**[Docket No. FAA–2009–1253; Directorate Identifier 2009–NM–080–AD; Amendment 39–16629; AD 2011–06–05]**

**Airworthiness Directives; The Boeing Company Model 737–600, –700, –700C, –800, –900, and –900ER Series Airplanes**

**ACTION:** Final rule.

**Figure 1**

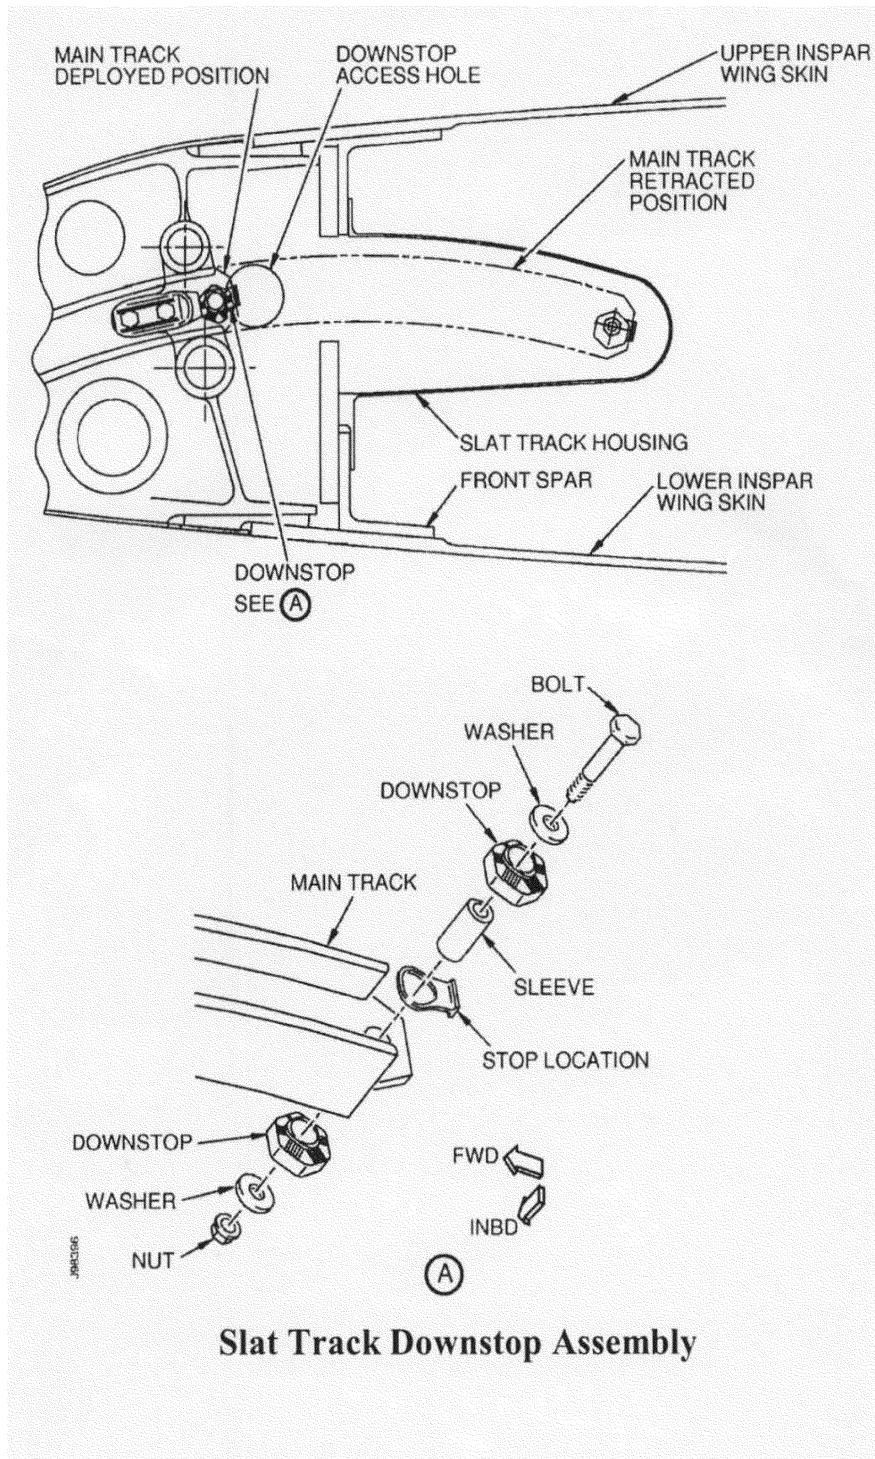
- (g) Within 10 days after September 26, 2007 (the effective date of AD 2007–18–52): Do a detailed inspection or a borescope inspection of each main slat track downstop assembly to verify proper installation of the slat track hardware (*i.e.*, the bolt, washers, downstops, stop location, and nut shown in Figure 1 of Boeing Service Letter 737–SL–57–084–B, dated July 10, 2007, and in this AD). Proper installation of the sleeve need not be confirmed, and the stop location part may be installed on either the inboard or the outboard side of the slat track. If any part is missing or is installed improperly, before further flight, install a new or serviceable part using a method approved in accordance with the procedures specified in paragraph (j) of this AD; and do a detailed inspection of the inside of the slat can for foreign object debris (FOD) and damage. Before further flight, remove any FOD found and repair any damage found using a method approved in accordance with the procedures specified in paragraph (j) of this AD. Verify proper installation; install a new or serviceable part; and inspect for damage and FOD, and remove FOD and repair damage; in accordance with a method by approved by the Manager, Seattle Aircraft Certification Office, FAA; or in accordance with Boeing Multi Operator Message Number 1–523812011–1, issued August 25, 2007, or 1–527463441–1, issued August 28, 2007. Repeat the actions required by paragraph (g) of this AD thereafter at intervals not to exceed 3,000 flight cycles.

- (h) Within 24 days after receipt of emergency AD 2007–18–51: Apply a torque between 50 to 80 inch-pounds to the nut. The bolt head must be held with the torque applied to the nut.
